Wisconsin Department of Transportation

Proposal #42: 9545-00-72, WISC 2025490
V Rib Lake, State Road
Little Rib River River Bridge B-60-018
Loc Str
Taylor County

This is Addendum No. 01, which provides for the following:

Addendum No. 01
ID 9545-00-72
Revised Sheet 41
April 22, 2025

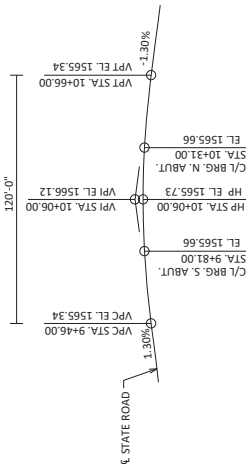
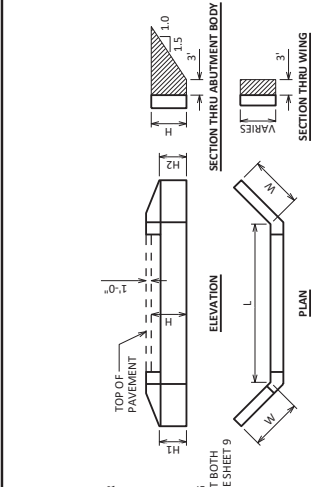
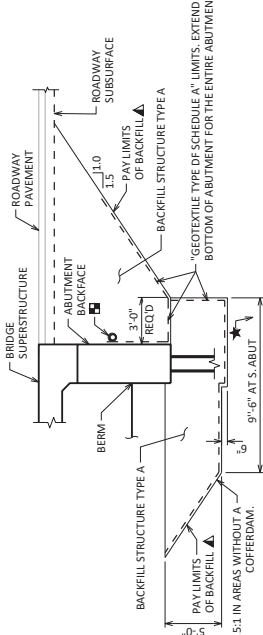
Revised Plan Sheets	
Plan Sheet	Plan Sheet Title (brief description of changes to sheet)
41	Cross Section, Quantities & Notes (Revised Bar Steel Quantities)
44	South Abutment Details (Revised Bill of Bars)
46	North Abutment Details (Revised Bill of Bars)

505.0400	BAR STEEL REINFORCEMENT HS STRUCTURES	LB	2060	2060	20380	4120
505.0600	BAR STEEL REINFORCEMENT HS COATED STRUCTURES	LB	1955	1955	20380	24290
513.4051	RAILING TUBULAR TYPE M	LF	-	-	109	109
